Planning Commission Staff Report

Subject: Rezoning Vote Report

Petition: P.Z. 30-2007 Spirit Energy, LLC (13506 Olive)

PRELIMINARY DEVELOPMENT PLAN

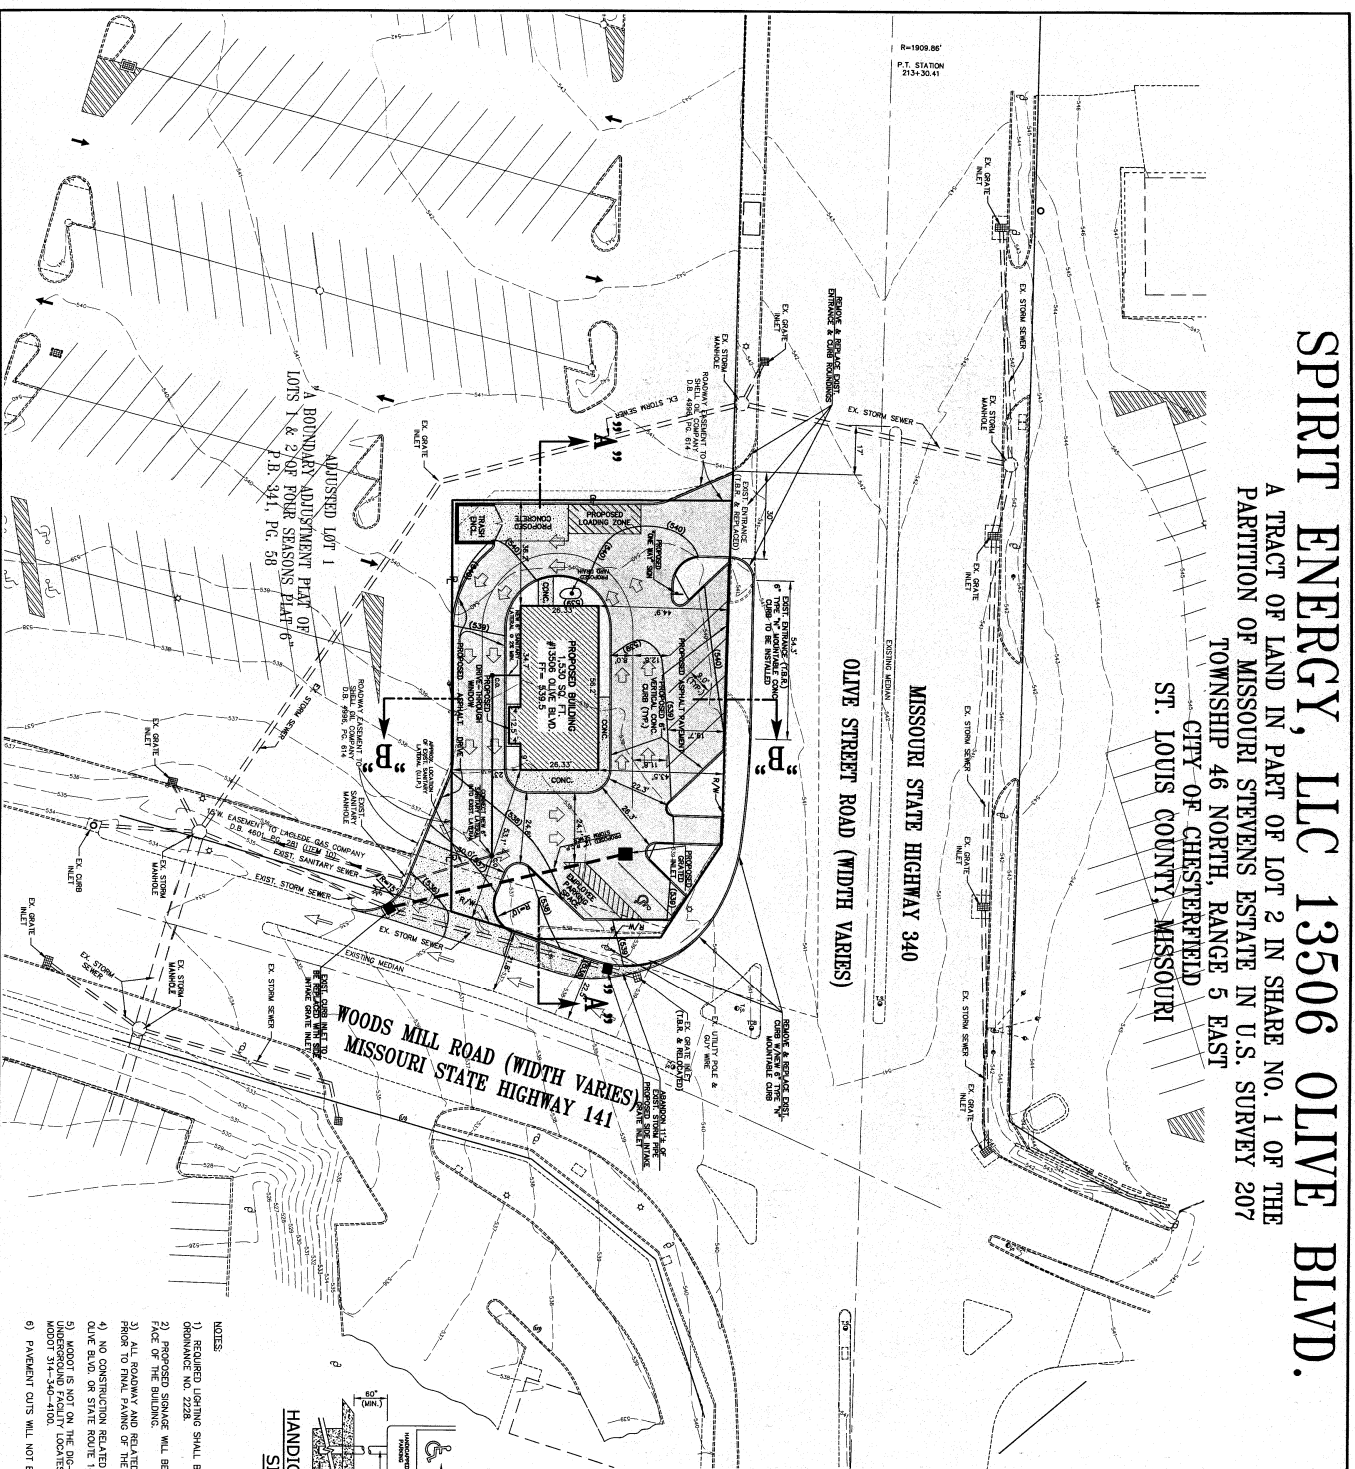
12. The preliminary plan still depicts a potential traffic conflict at the entrance onto Route 141. In addition, the pavement widening actually reduces the driveway throat length and brings the traffic conflict closer to the roadway pavement than previously submitted plans. This is being worked on with the advice of MoDot.

14. The Preliminary Plan indicates that the vehicles that will be using the drive thru lane will not be able to stay within the limits of the drive thru lane. Even a passenger car will encroach on the adjacent travel lane which will likely impede traffic flow within the site and increase the possibility of traffic conflicts on the adjacent roadways. The drive thru lane will be adequately wide enough to allow a vehicle to stay within its limits.

15. A single unit truck can not traverse through this site. In addition, if a single unit truck, such as a trash truck comes onto the site from Olive Boulevard and then exits via State Route 141, the truck will not be able to exit without driving over the curb. In addition, the single unit truck can not enter the site from State Route 141 and successfully negotiate the necessary turns to reach the trash enclosure or the loading space provided on the western parcel line. A trash truck will be able to exit onto hwy 141 in the same manner it does from adjoining properties. They will enter the lot from Olive Blvd.

16. The plan indicates that the curb along Olive Boulevard will be replaced with a mountable curb directly adjacent to the proposed five (5) foot wide sidewalk. The curbing in this area will need to provide a barrier between pedestrian and vehicular traffic. We will discuss this with the City of Chesterfield and MoDot to resolve the issue. We are under the impression that MoDot would prefer not to have a sidewalk, as there are no sidewalk's currently at this intersection.

17. Please be advised that the proposed no entrance sign located near the entrance at Olive Boulevard will need to be relocated such that it properly directs and informs drivers of on site traffic flow direction. The plan appears to inform drivers that they can not enter the site from Olive Boulevard. The sign can be relocated.
